INNER WEST COUNCIL

DEVELOPMENT ASSESSMENT REPORT

Application No.	10.2019.109.1
Address	164 Frederick Street, Ashfield
Proposal	Demolition of existing structures and construction of a 3 storey serviced apartment building with 33 rooms, basement car parking, signage and associated landscape works.
Date of Lodgement	18 July 2019
Applicant	Sonar Australian PTY LTD
Owner	Sonar Australian PTY LTD
Number of Submissions	Two (2)
Value of works	\$4 935 695.00
Reason for determination at Planning Panel	Clause 4.6 variation exceeds 10%
Main Issues	Non-compliance with development standards, streetscape impacts, amenity impacts to neighbours and traffic/parking
Recommendation	Refusal
Attachment A	Reasons for refusal
Attachment B	Plans of proposed development
Attachment C	Conditions of Consent

Attachment B – Plans of proposed development

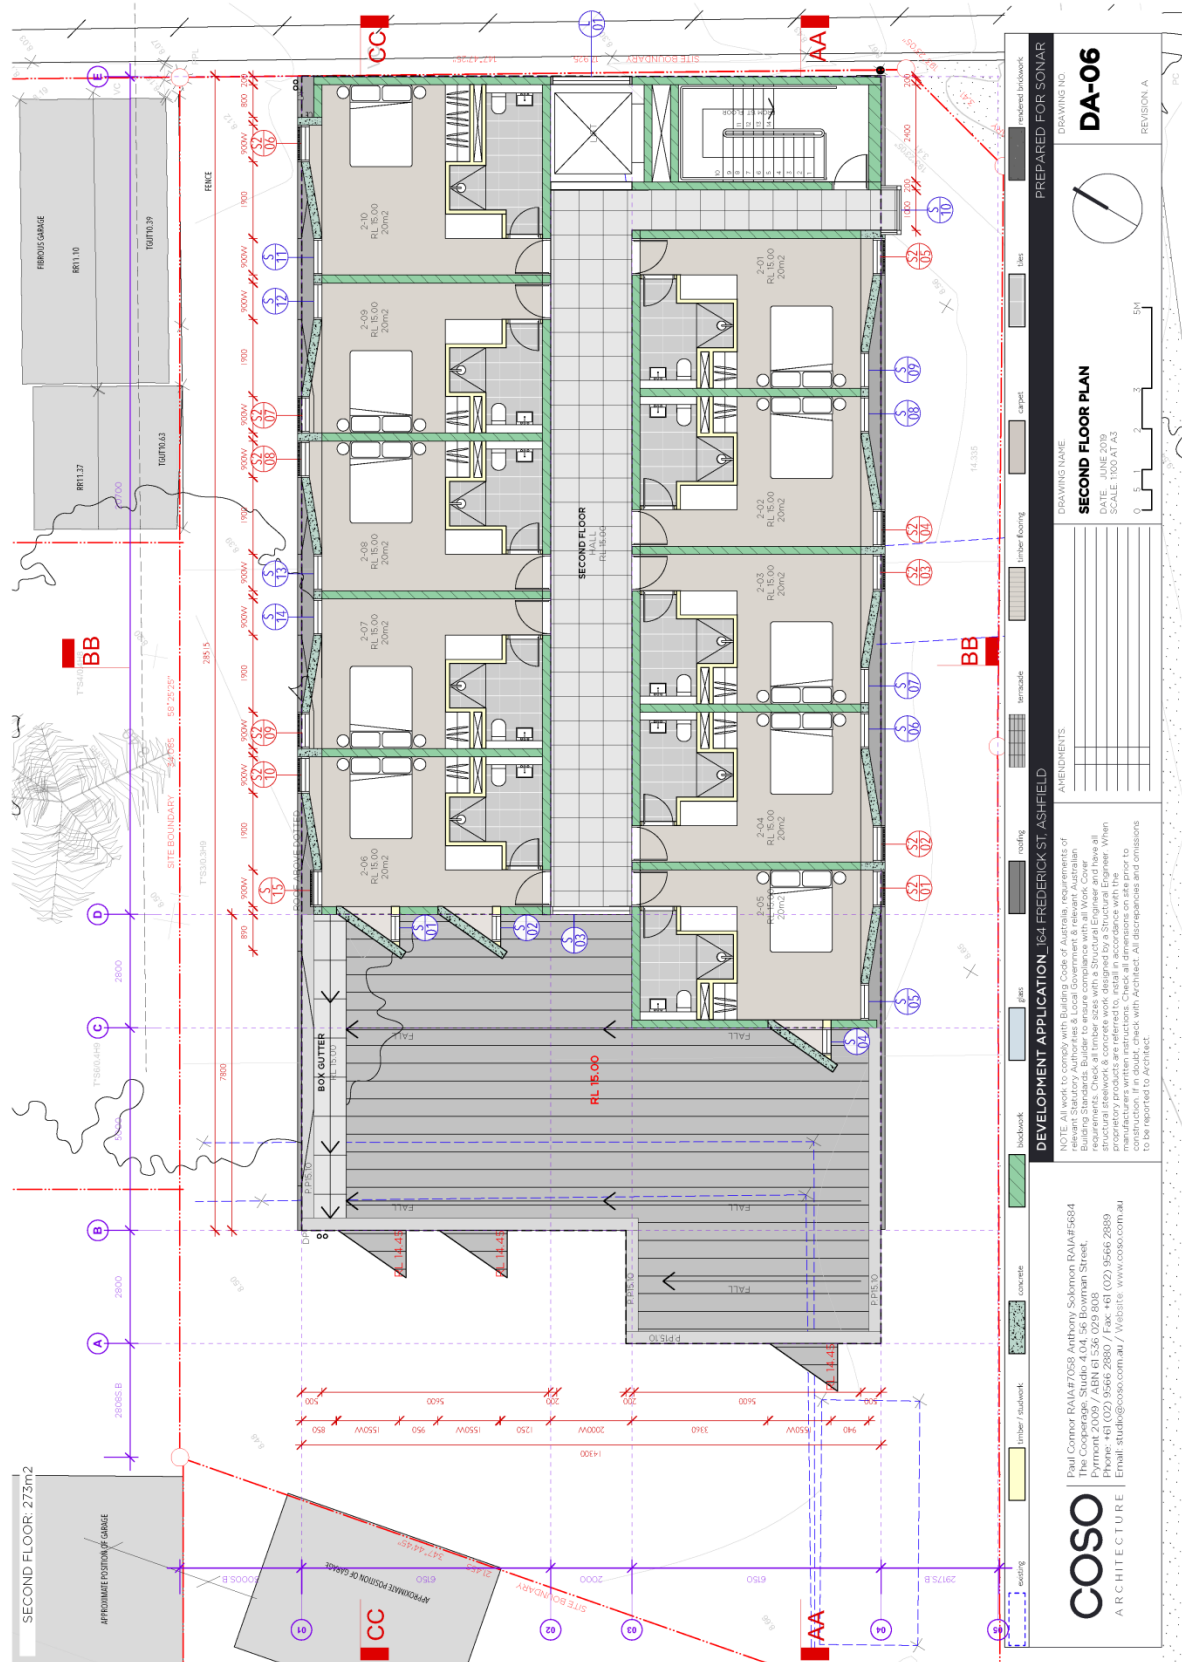
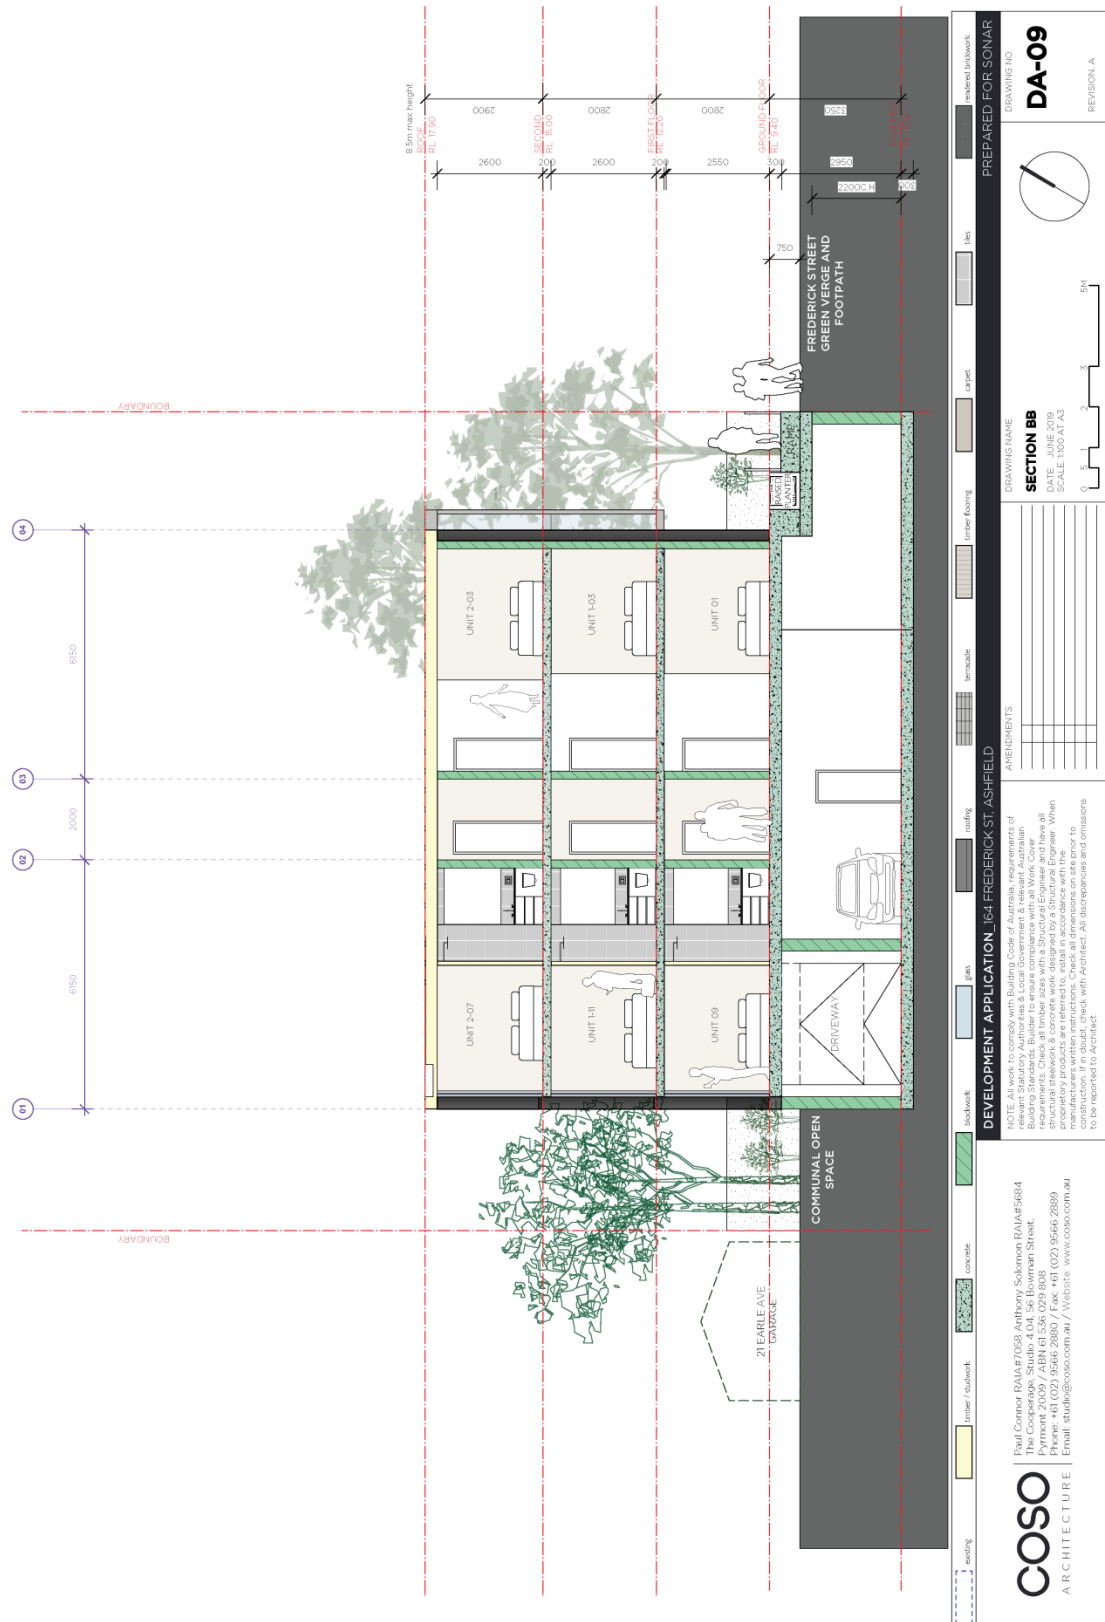
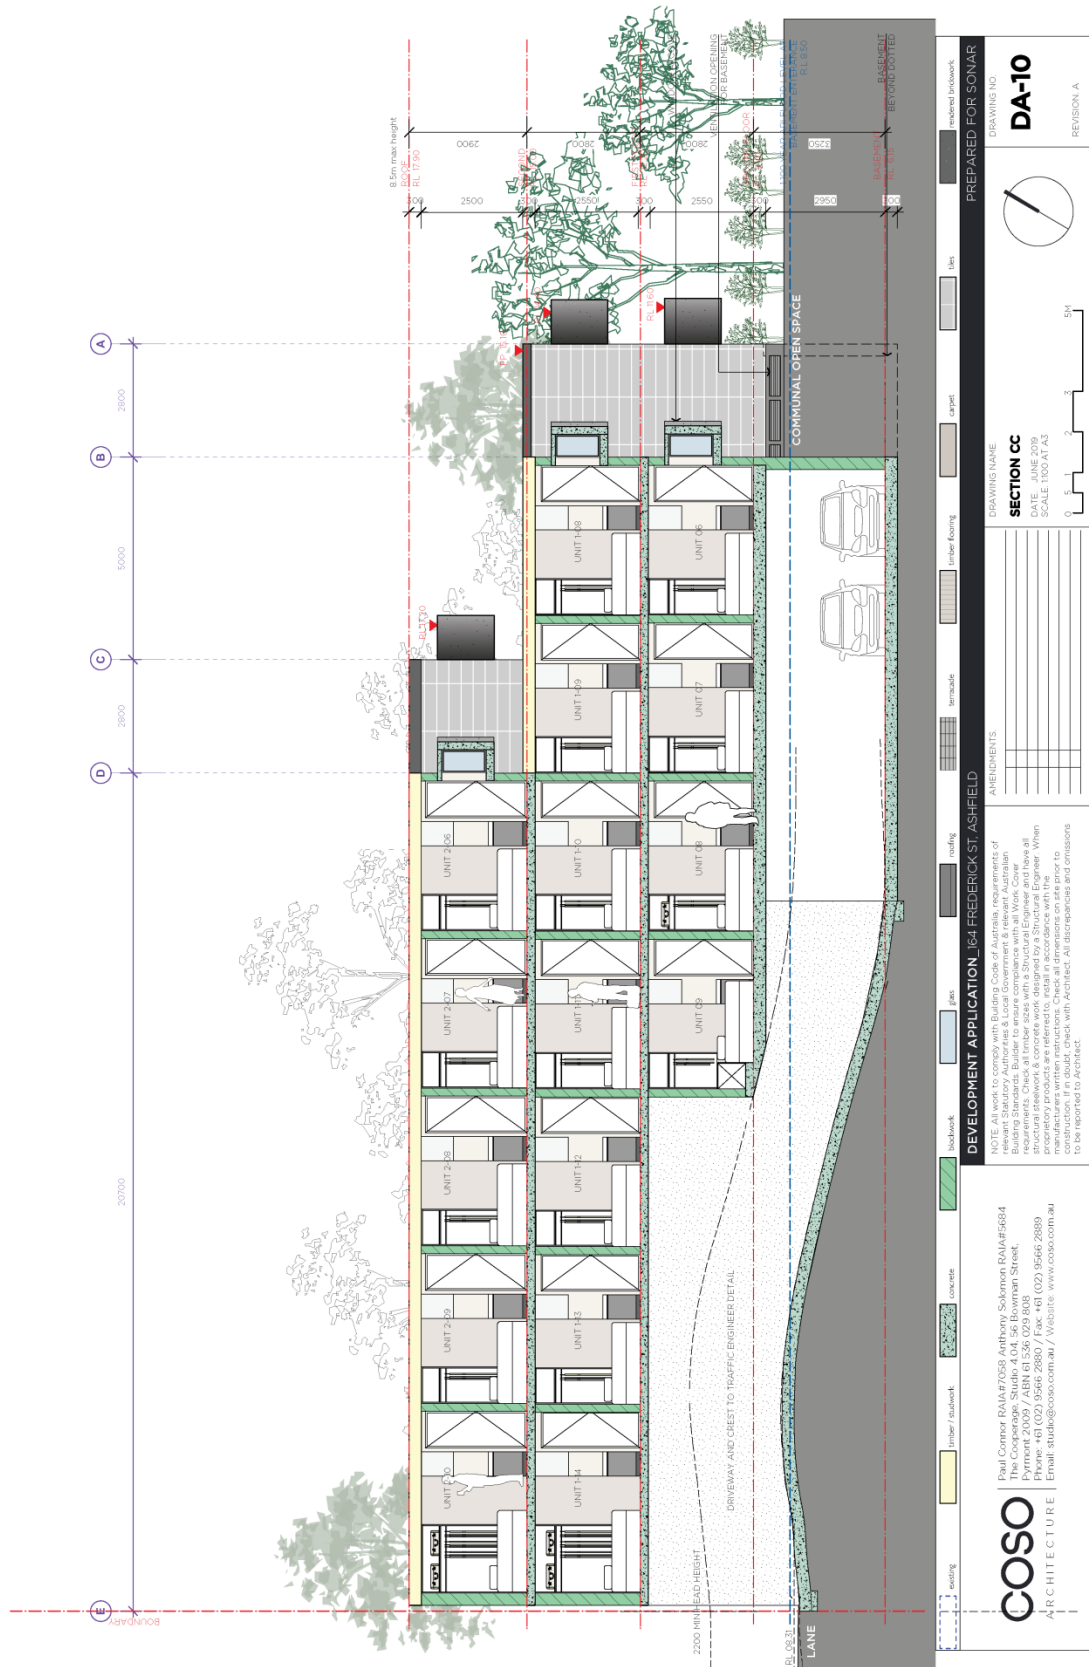
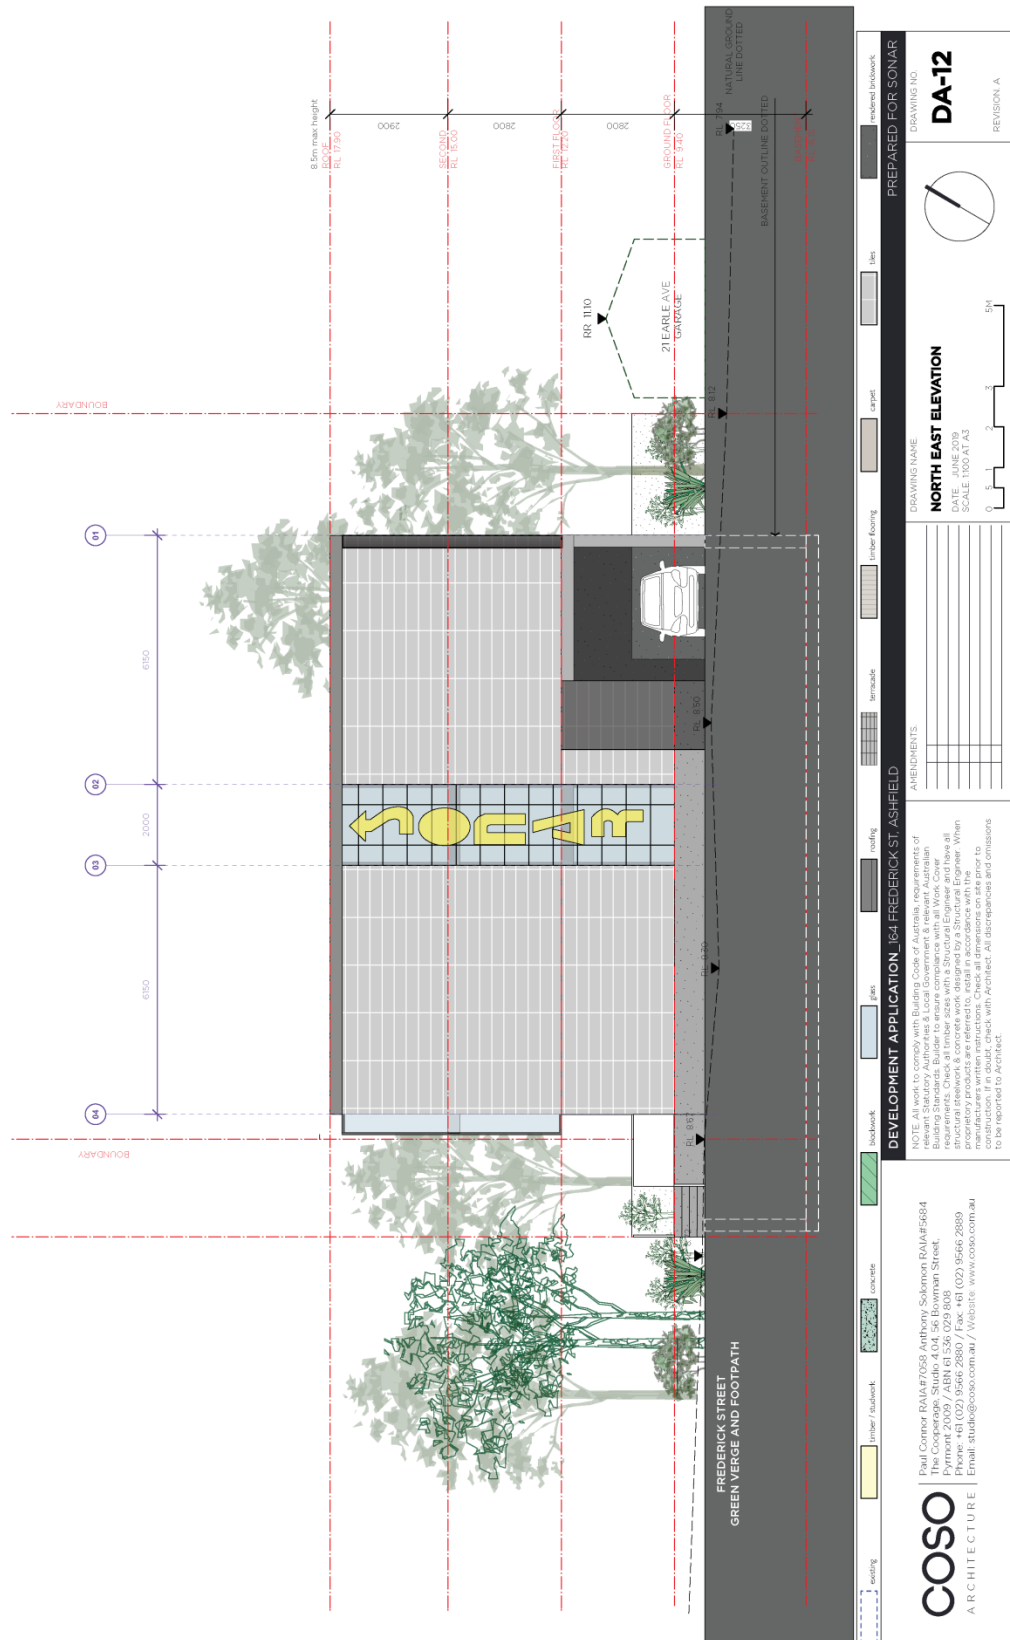
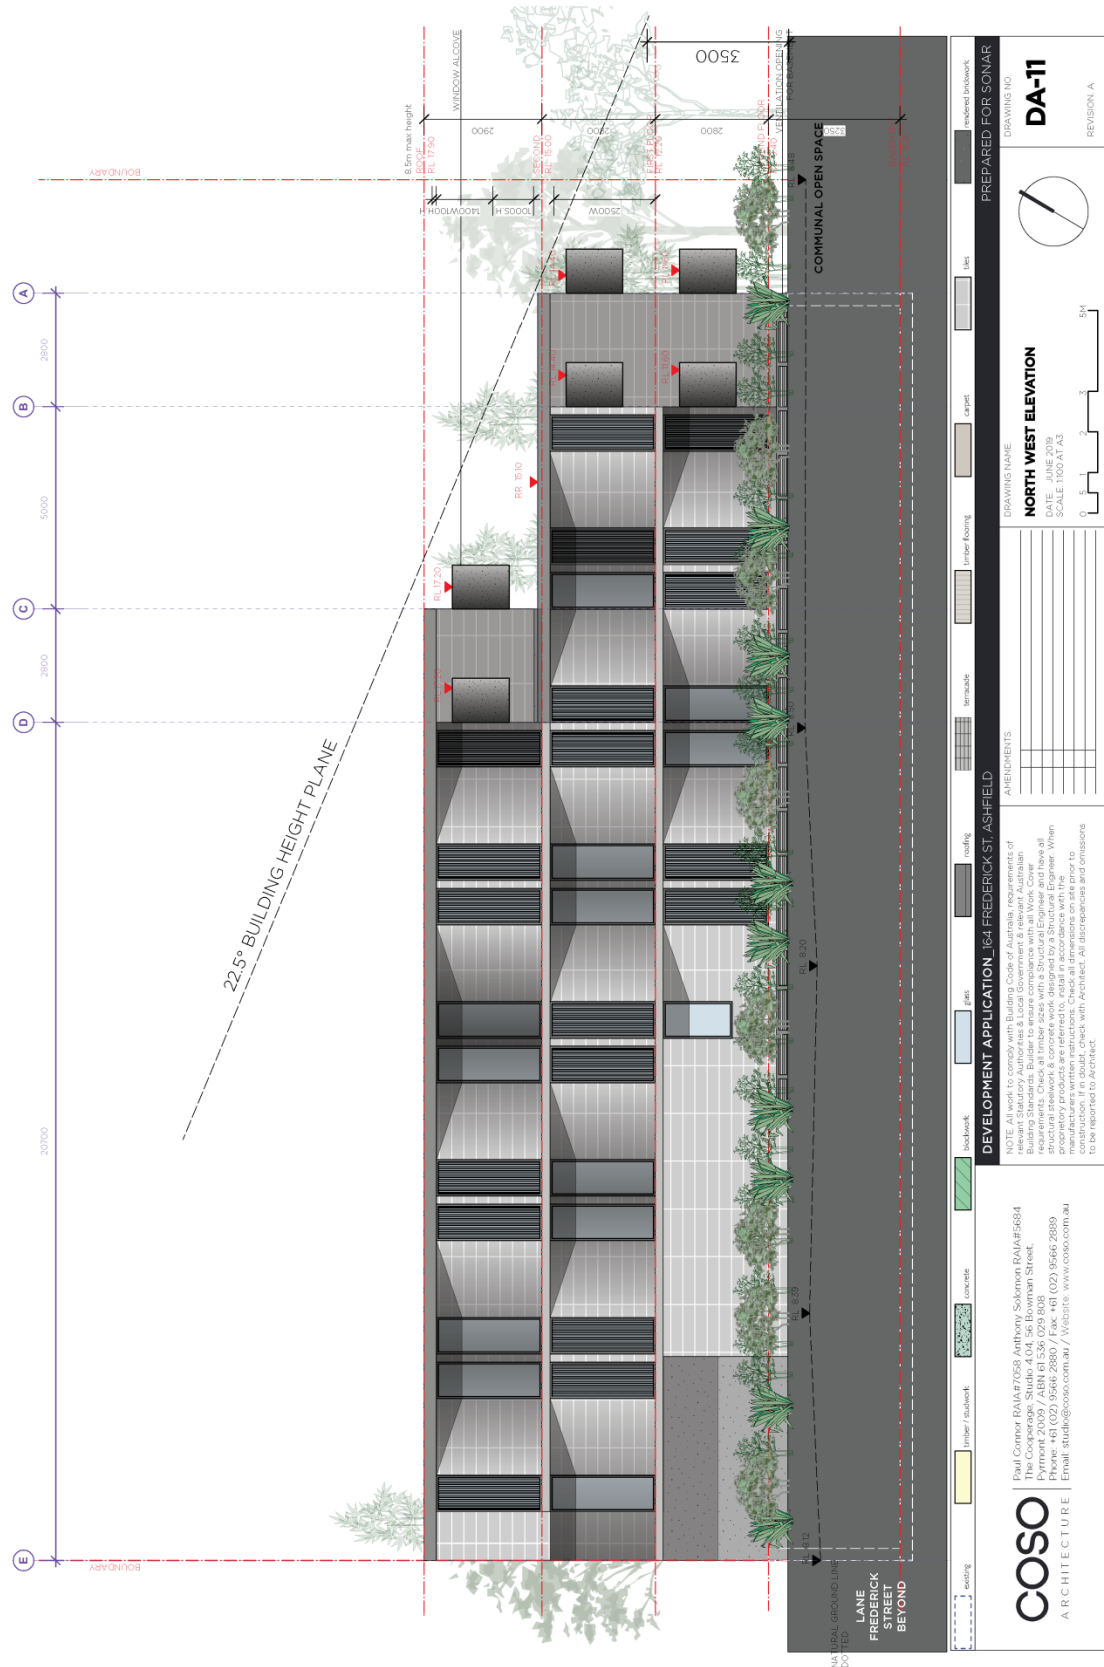
Plans provided by the applicant currently fail to represent the correct height of the proposed building as they incorporate an inaccurate 8.5m maximum height line. This has been analyzed against the proposed roof RL and existing natural ground RL which has highlighted the proposed height variation.

- *The panel considers that in its current form the building provides a poor presentation of its front address to Frederick Street and that the proposed entrance creates a pinch point as a result of its location and change of height of the finished floor level relative to the ground level. The panel considers that any change of level should be omitted, or managed within the building rather than its external interface.*

- *The proposed communal open space to the rear does not provide an acceptable relationship with the ground floor*

Plans currently provided do not detail the proposed location of key services such as fire hydrant boosters or electrical substations. These services are required under the BCA and have significant potential to disrupt streetscape and good urban design outcomes if not appropriately treated/screened.

The proposal is recommended for refusal based upon the matters discussed within this report, however in the event that amended plans are submitted or that the development application is approved then it is recommended that a condition of consent requiring the display of such services upon the stamped plans be imposed.
